IDAP REPORT

Property:	101 Juno Parade GREENACRE DA 2020/073
Proposal:	Demolition of existing buildings and construction of a dual occupancy and Strata title subdivision.
Applicant:	Ultra Design & Eng
Owner:	Tannous & Angela Hosni
Date of lodgement:	22 April 2020
Notification period:	24 April 2020 – 20 May 2020
Submissions received:	Nil
Assessment officer:	L Gibson
Estimated cost of works:	\$950,500.00
Zoning:	R2 Low Density Residential- SLEP 2012
Heritage:	N/A
Flood affected:	No
Is a Clause 4.6 Variation Proposed:	No
RECOMMENDATION OF OFFICER:	APPROVAL

Figure 11: Excerpt from Submitted Vehicle Swept Path Analysis demonstrating driveway location, turning bay and hardstand parking spaces in the front setback of the site.

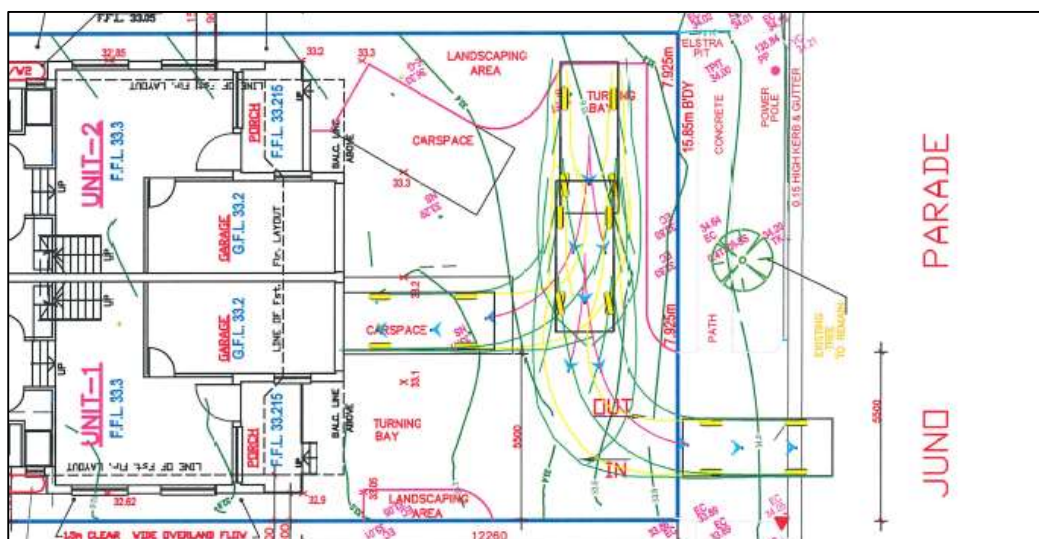
Each dwelling is provided with a single garage and a second car parking space provided within the front setback of the site. The site is heavily constrained by its direct frontage to classified Road (Juno Parade) as well as the Council street tree located directly in front of the property. This has limited opportunities for siting of a dual driveway as well as providing adequate off-street parking for the development. The proposal has been redesigned throughout the assessment process to accommodate a new 5.5m driveway upon the far western-side boundary of the site with a turning bay provided within the front setback (refer below to Figure 11).

This is considered the most suitable and appropriate option which best addresses TfNSW requirements for vehicles to enter and exit the site in a forward motion as well as Council's requirements for retention and protection of the street tree located on the Council verge.
